RE: Richard Beland – Lot 38 Purfoy Place

May 5, 2022

Job	Truss	Truss Type	Qty Ply 38 Purfoy Place-Emma-Roof	38 Purfoy Place-Emma-Roof		
22010043-C	B4	Piggyback Base	7	1	Job Reference (optional)	150325938

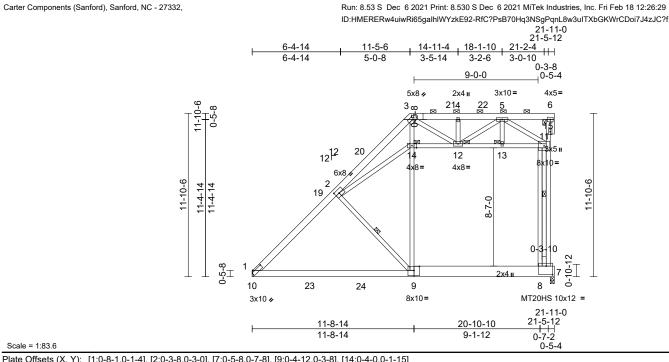
It was brought to our attention that the that there was concern about no bearing at the top of trusses B4 & B5. The trusses were designed with only the bottom of the truss supported and no support at the top chord. See detail below:

After examination of the trusses in question it was determined that the trusses are installed as designed and no repairs or adjustments are needed.
